# Access Compliance Report

## Public Rights-of-Way

Intersection ID: 53744	Main Street: SMITH_RD	Cross Street: CANTERBURY_CASTLE_DR	Location: NW
ADA ID: B9A04571099B	Ramp Type: BlendTrans1	Initial Pass/Fail: Fail	Overall Compliance: No
			Severity Score: 33.75

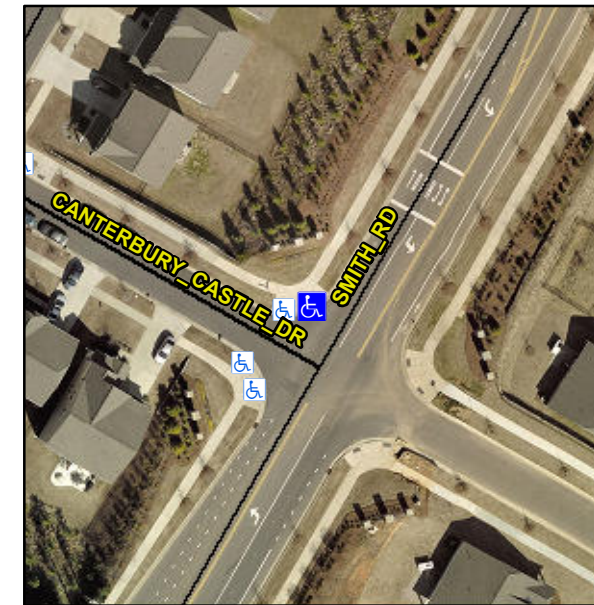
**Not Found, R304.5.1, R304.5.3**

Compliance	Description	Data	Compliance	Description	Data
N/A	Ramp Length (in)	96.0	Yes	BlendTrans Slope (%)	4.2
No	Ramp Width (in)	47.0	No	BlendTrans XSlope (%)	8.1
N/A	Flare Type LT	N/A	N/A	Flare Type RT	N/A
N/A	Flare Slope LT (%)	N/A	N/A	Flare Slope RT (%)	N/A
N/A	Flare Traversable LT?	N/A	N/A	Flare Traversable RT?	N/A
N/A	Landing Length (in)	N/A	N/A	DWS Provided?	N/A
N/A	Landing Width (in)	N/A	N/A	DWS Contrast?	N/A
N/A	Landing Slope (%)	N/A	N/A	DWS Length (in)	N/A
N/A	Landing X Slope (%)	N/A	N/A	DWS Full Width?	N/A
N/A	Landing Curb? (Y/N)	N/A	N/A	DWS Offset (in)	N/A
N/A	Shared Landing?	N/A			
N/A	Gutter Ponding?	N/A	N/A	Gutter Slope (%)	N/A
N/A	Gutter Lip Ht (in)	N/A	N/A	Gutter X Slope (%)	N/A
N/A	Painted X Walk1?	No	N/A	Painted X Walk2?	N/A
	X Walk 1 Direction	To SE		X Walk 2 Direction	N/A
	X Walk 1 Width (in)	N/A		X Walk 2 Width (in)	N/A
	X Walk 1 Slope (%)	5.2		X Walk 2 Slope (%)	N/A
	X Walk 1 X Slope (%)	7.1		X Walk 2 X Slope (%)	N/A

N/A	Ramp inside XWalk1?	N/A	N/A	Ramp inside XWalk2?	N/A
	Road Slope (%)	7.1		Clear Space?	N/A
	Road X Slope (%)	5.2	N/A	Clear Space to XWalk (in)	N/A
N/A	Any Obstructions?	N/A	N/A	Storm Grate/Utility Hazard?	N/A
	Obstruction Type			Storm Grate/Utility Type	
		N/A			N/A
			Yes	Surface Condition? (G/P)	Good
			No	Curb Slope (%)	6.2

**Remove & Replace Curb Ramp With Two New Directional Ramps or Equivalent.**
